**ATTACHMENT 6**

**SUPPLEMENTAL STANDARDS FOR  
DURANGO PROCESSING SITE**

**SUPPLEMENTAL STANDARDS APPLICATIONS FOR  
REGION I ADJACENT TO ANIMAS RIVER**

**SUBJECT:** Proposed Durango Site RAP Mod. Rev. 2, Animas River Bank

**FIGURE 3**

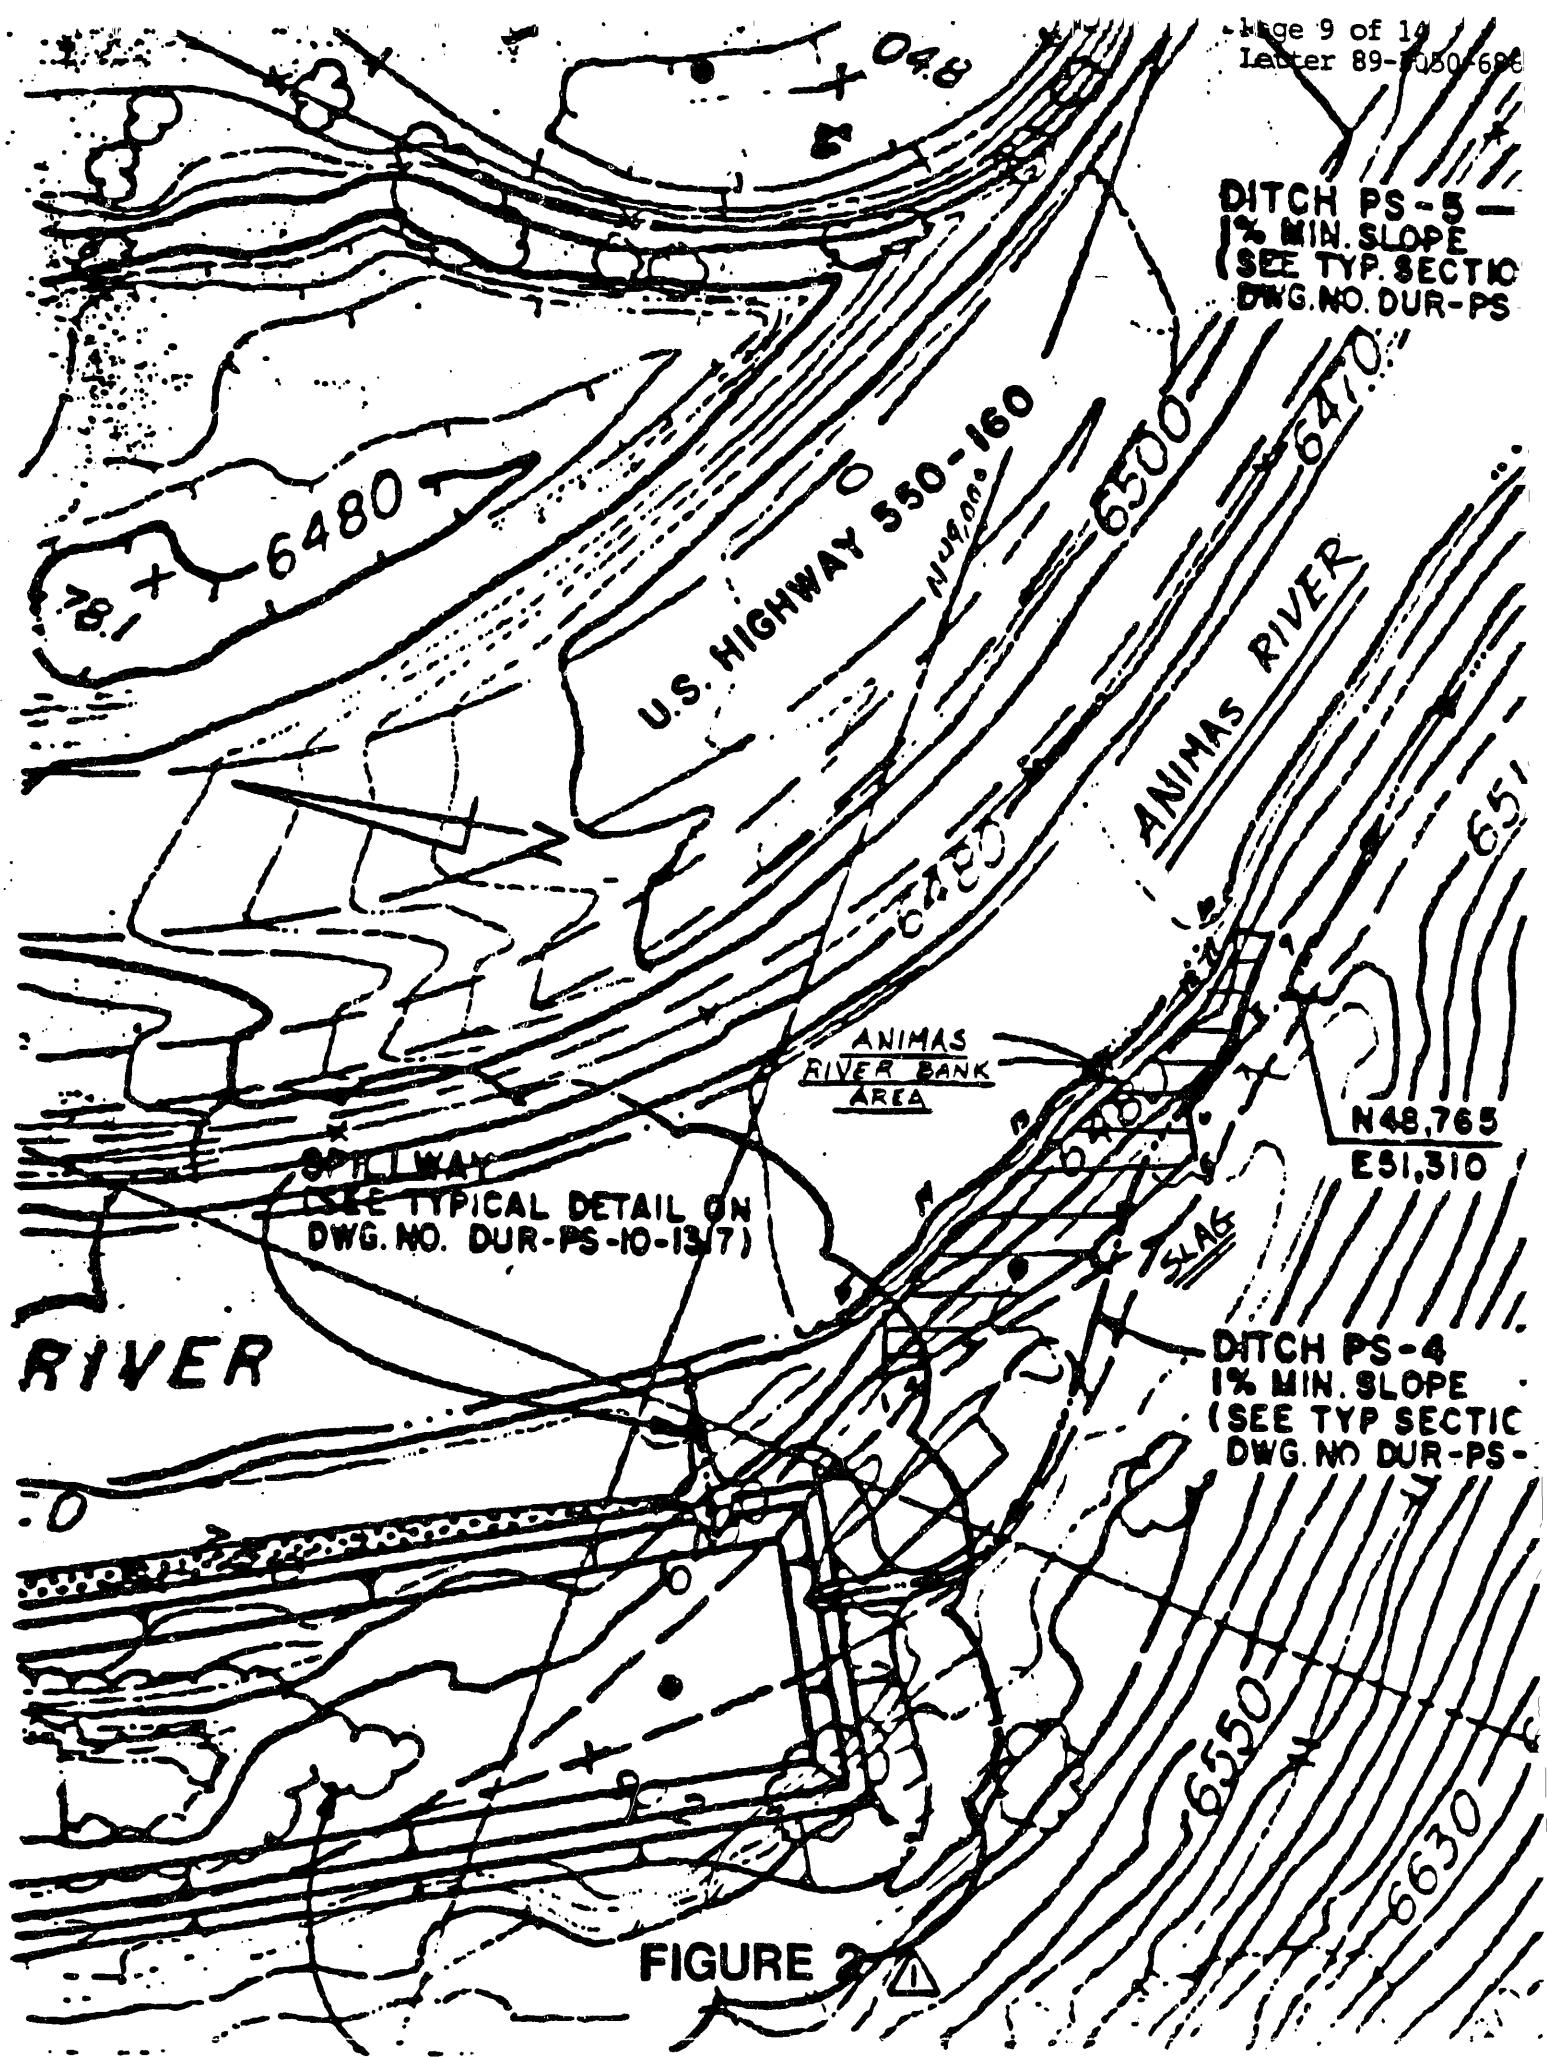
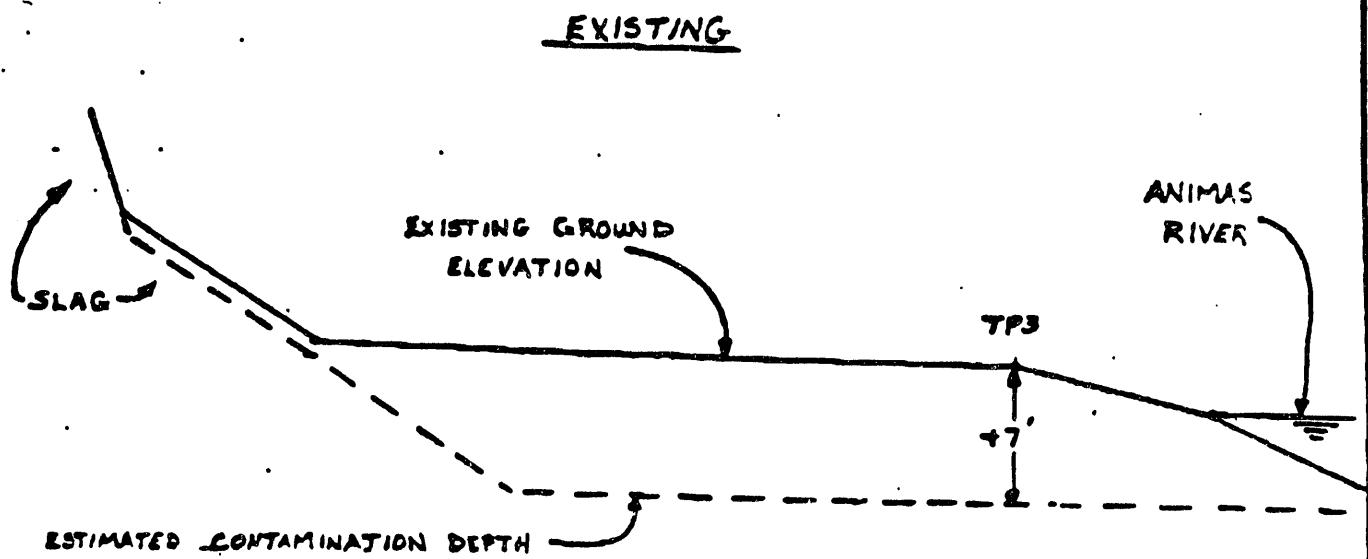
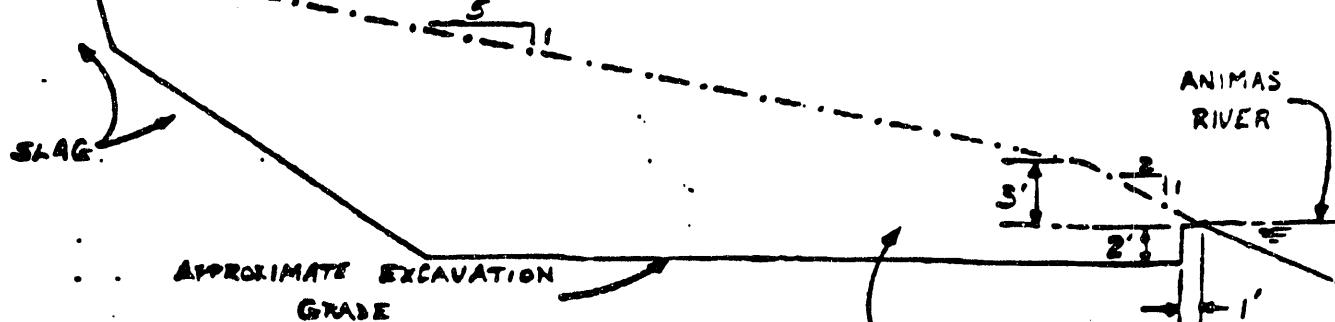
We agree that supplemental standards are applicable for the residual material along the Animas River. Supplemental standard approval is for the area described in Figure 2 of your submittal only. We have concluded that the supplemental standard criteria (40 CFR Part 192.21) concerning risk of injury to workers and environmental harm to be applicable to this proposal.

During a visit to the site on September 6, 1989, members of my staff observed this particular area along with several other areas that are currently being considered for supplemental standards or vicinity property designation. While examining these areas, a small "seam" of crystallized uranium salts which has formed along the river bank along the slag and original ground interface was pointed out. The deposit is thought to be the result of an old spill on the slag pile that is slowly leaching through the slag and daylighting at the river bank. Due to problems encountered with excavating and drilling in the slag, the extent of this uranium deposit has not been defined.

Your staff indicated that DOE has no plans to cleanup this area as the hazard averaged over the entire slag pile will be negligible. We do not consider this to be consistent with the approach of reducing exposure to the public to levels

as close to the standards as is reasonably achievable. Therefore we suggest that DOE reexamine the possible hazard to the public along the accessible river bank.

EXCAVATION DEPTH MAY INCREASE AT  
THE DIRECTION OF THE CONTRACTOR  
IF GROUND WATER CONDITIONS  
ALLOW

GENERAL FILL WITH ROCK  
MATERIAL PLACED ADJACENT  
TO RIVER AND BELOW WATER  
LEVEL.

**FIGURE 1**

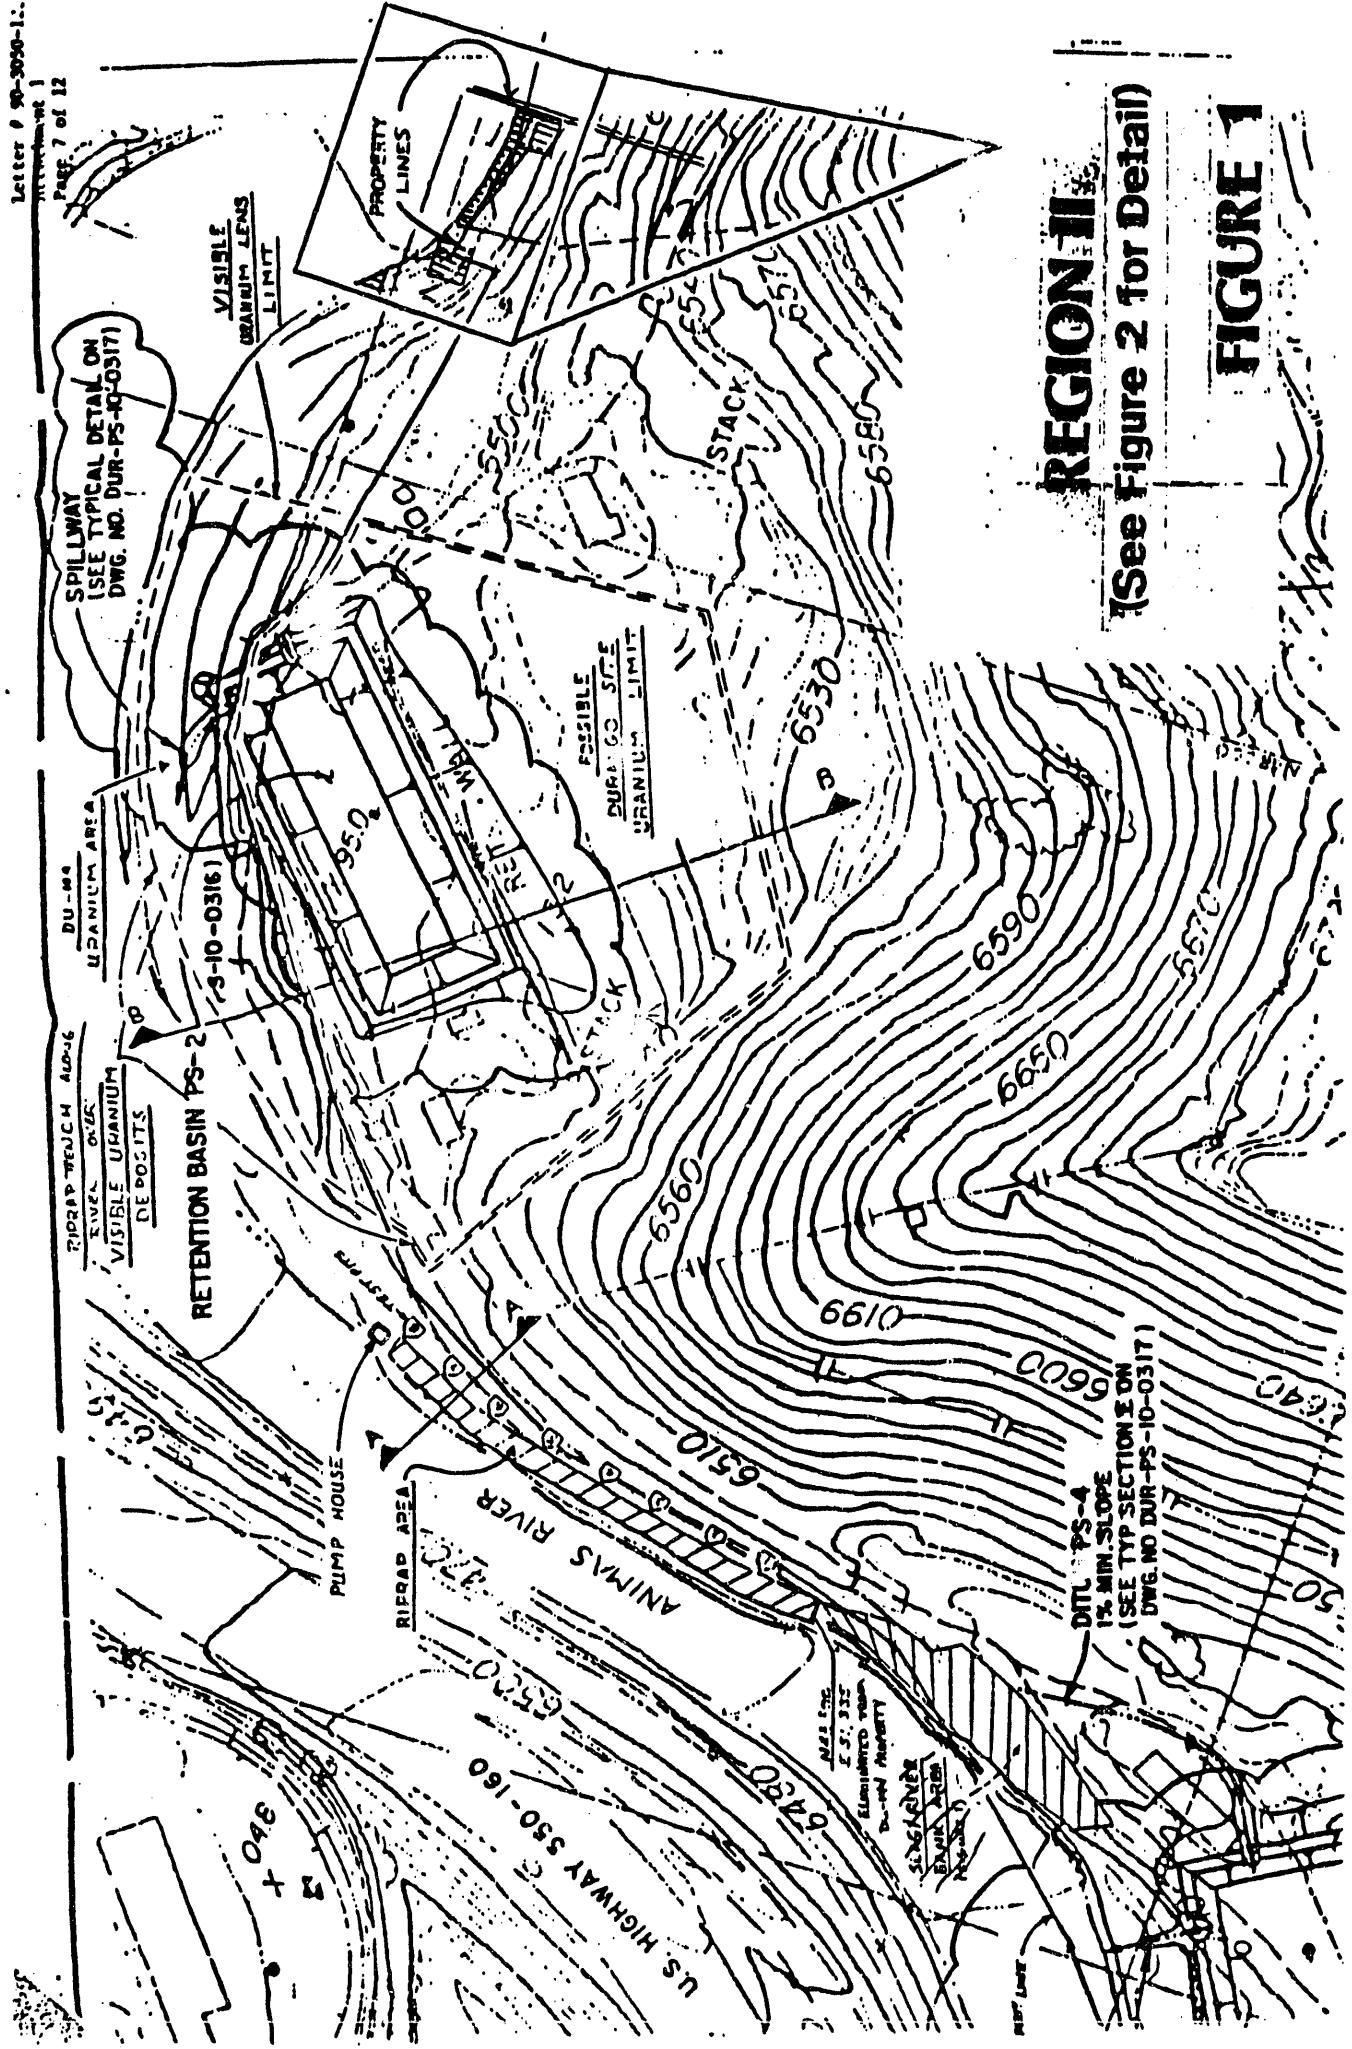
First, the documentation does not provide any data to substantiate the estimated depths of contamination. Based on conversations with members of the MK-F staff, this data is not available. Therefore, the documentation should provide justification as to how these depths were estimated. Possibly, they may have been based on simply professional judgement or field experience with similar deposits on the Durango site. The basis for the estimates should be provided along with any supporting evidence.

Second, one of the areas (2C) contains an estimated two cubic yards and is not very close to the water's edge. The documentation does not provide any justification as to why this small deposit could not be removed. Based on our experience with the adjacent vicinity property, we realize that the area in question is at the bottom of a steep cliff and is not accessible along the bottom of the cliff except by entering the river. We also realize that this deposit is contiguous with a deposit on the vicinity property, which would result in an excavation volume much larger than the two cubic yards within the designated site. We recommend that this information be incorporated into the documentation to justify leaving the small deposit within the designated site.

Option 2 - Partial decontamination: The contamination in Areas 2A and 2C has been excavated to one foot below the water table and covered, on average, with 10 feet of backfill. The contamination in Area 2B was left in place. Option two recommends that all three of these Areas be left in their present condition. This would require the application of Supplemental Standards. MK-Ferguson recommends that Supplemental Standards be applied to these areas based on conditions outlined in Modification No. 1 to the Durango, Colorado Final Remedial Action Plan (Rev. 1, dated 6/23/89).
